RE: Request for Maintenance Actions and Project Criteria

WSSA (WA Sensible Shorelines Association) is represented on the County Willowmoor project and, over the last several years, has been an active voice, through its members, in seeking resolution to ongoing issues with lake water levels and property flooding. This correspondence expresses our continued concern with both subjects and urges the County to move forward this year to complete sediment removal from the Transition Zone (TZ) at Marymoor Park.

Figure 10 - Comparison Issaquah Creek flow events and Lake Sammamish stage (H&H pg 25)

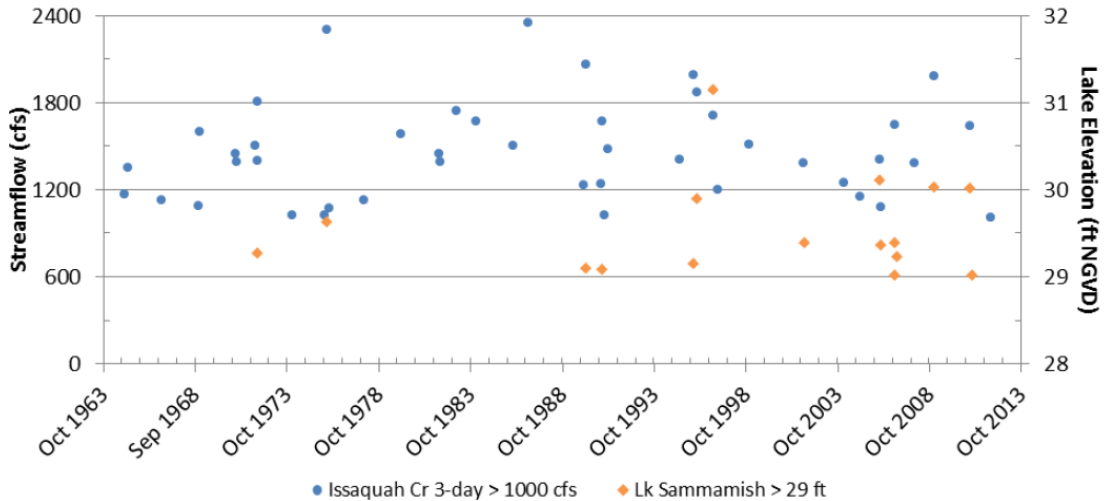
2. Design Flow - The consultant H&H report in Figure 10 (inserted below) shows **Issaquah Creek** historically and regularly has contributed inflows of 1500 cfs. This information was available to the ACOE in the 1960's and they most likely used it to establish their original design criteria. Obviously, **1500 cfs should be specified** in the Willowmoor project documents and used to guide project alternatives and their evaluation.

Figure 7. Annual distribution of daily lake stage. Minimum, mean, and maximum daily values are plotted for each water year.

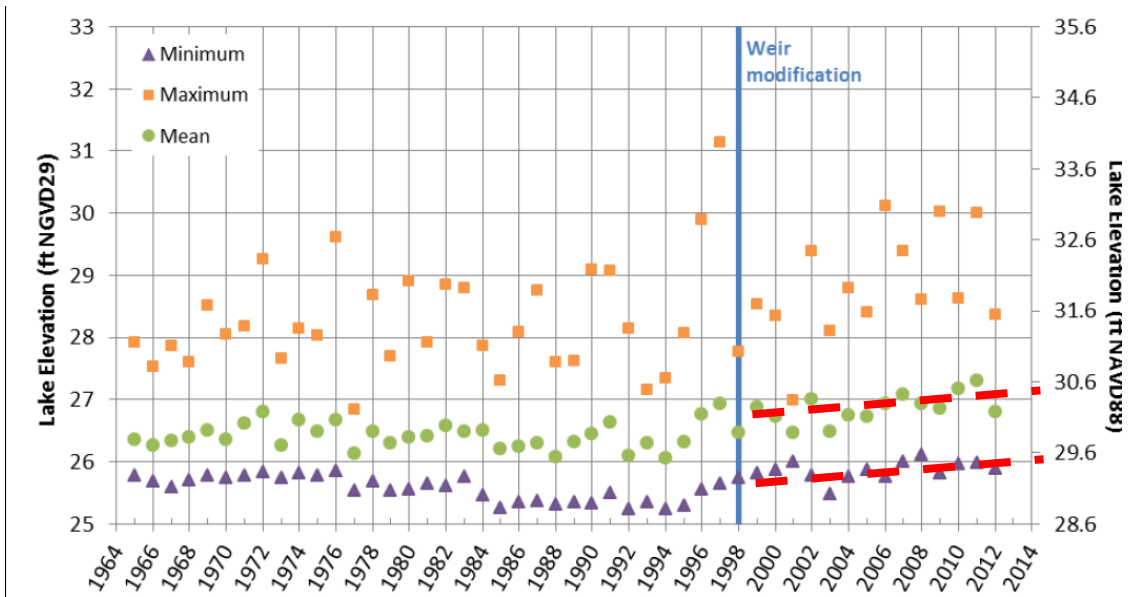
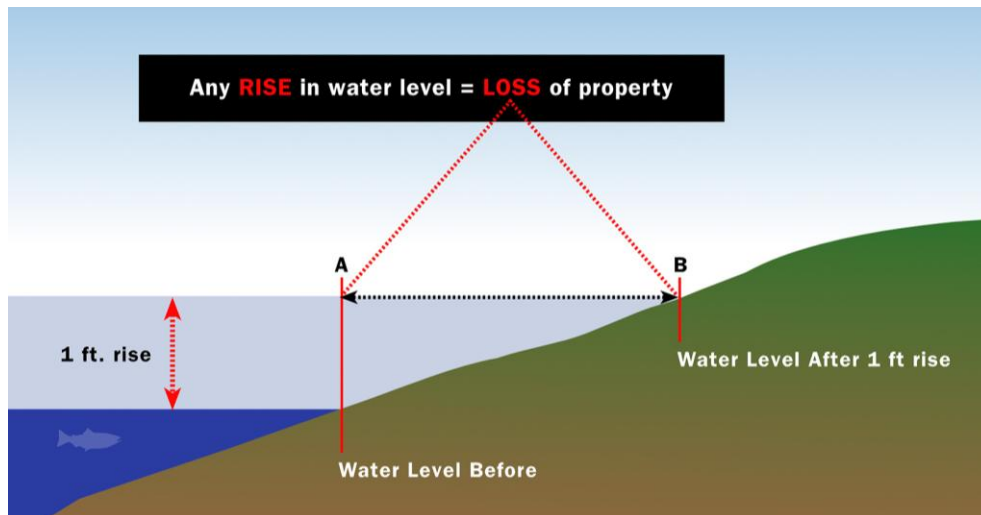
The trend reported by the consultant H&H was made clear in Figure 7 of their report⁴ as reproduced here with trend lines added.

Certainly a "fixed" weir would not cause this increasingly higher trend in water levels. Increasing levels of vegetation and sediment obstructing the high flow channels would.

The minutes of the Willowmoor SAC meeting held Feb. 12th state *recent low to moderate lake level (deteriorated) conditions are attributed to the weir modifications (of 1998)*. No mention is made that the report also implicates vegetation and blockages in the TZ. The project records and reports should be modified to include recognition of these causes.

Figure 11 Relationship between lake discharge and lake elevation for 5 sub-periods (H&H pg. 26)

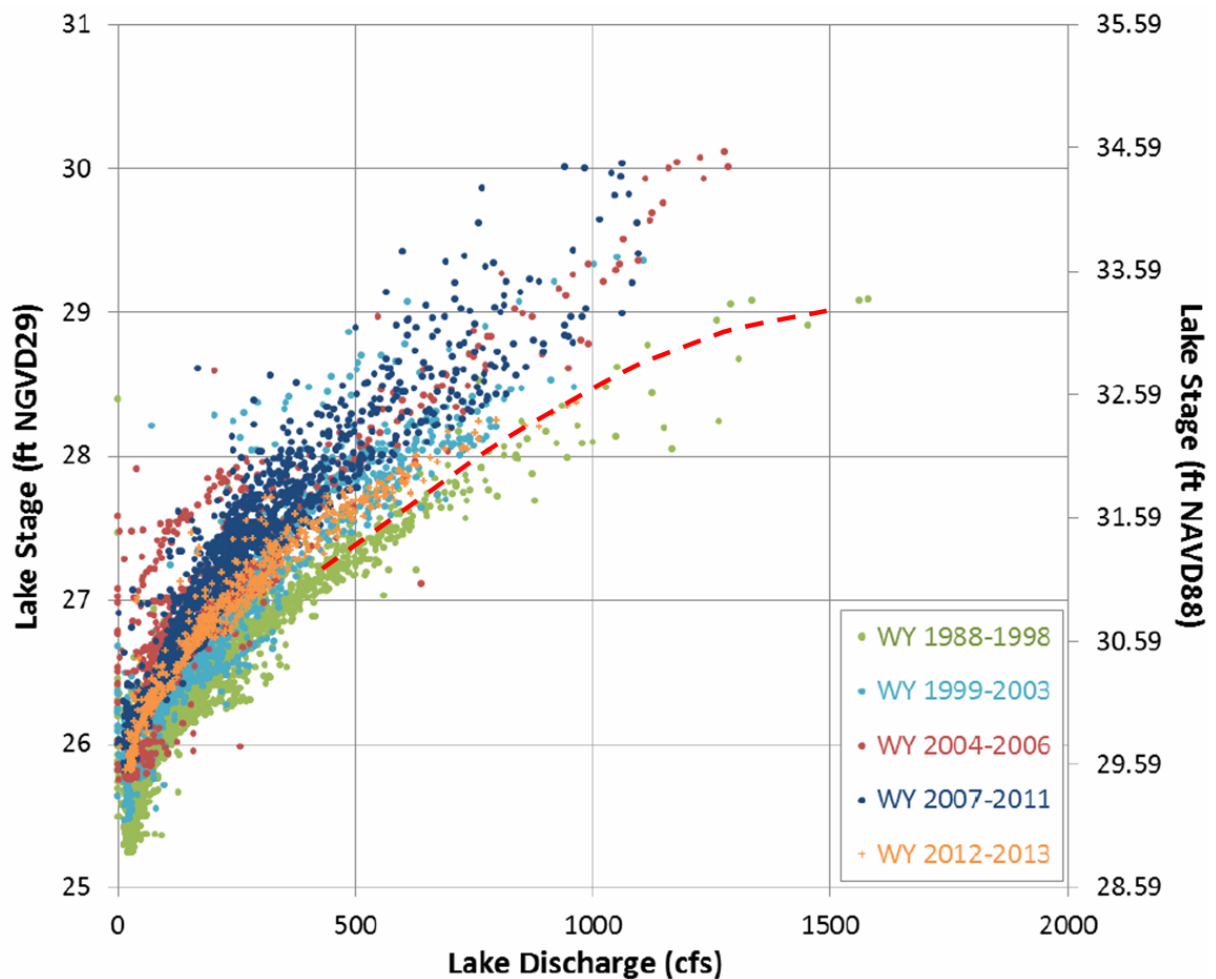
The consultant H&H Phase 1 report is also revealing with respect to the historic OHWM and the ability to pass the requisite flows at 29 ft. NGVD (and as important, flows at lower levels). Figure 11 of the H&H report reflects a period of 10 years from 1988 to 1998 (green dots in graph). The rating curve, which we have added (**dashed red line**) reflects the ability to pass greater amounts of flow than in subsequent periods; even reaching the 1500 cfs level when the lake was at 29 ft. NGVD.

While the consultant attributes the OHWM shift to a change in the elevation of the top of the reconstructed weir, one cannot exclude other, concurrent factors - namely: (A) the introduction of vegetation along the low flow channel and, (B) poor maintenance practices that ensued shortly after construction of the new weir.

We also point to other revelations in Figure 11. The **orange dots** are associated with years 2012 - 2013. Note that these are shifted in a more favorable direction with respect to flow (greater flow at lower lake levels). This attests to the effectiveness of the return to required levels of maintenance. However, since this 2012-2013 rating curve is not as low as the 1988-98 period, other action is appropriate - namely removal of the remaining sediment.
